Chint Power Systems Customers
CPS 100/125kW Inverter Users

SERVICE BULLETIN

CPS 100/125kW Wire-box Enclosure Torque Check – ACTION REQUIRED

Figure 3-16 Installation of the Wire-box

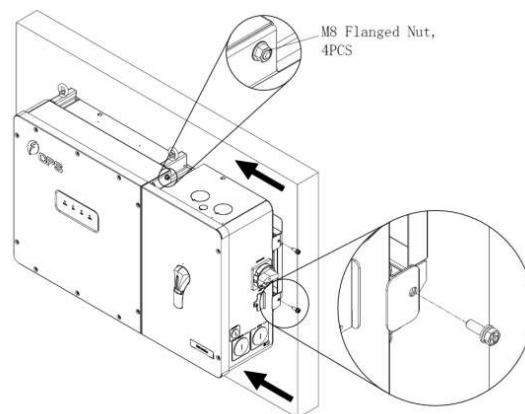
As stated in the 100/125kW User Manual, the wire-box must be connected to the main enclosure using the M8 Flanged Nut (4pcs) and **torqued to 110.6 in-lbs (12.5 Nm)**. The wire-box must also be secured to the bracket with the M6-18 combination screws and **torqued to 53 in-lbs (6 Nm)** as shown in Figure 3-16. This connection provides the ground bond for the Inverter (Main) Enclosure. Failure to properly install may result in shock or equipment failure.
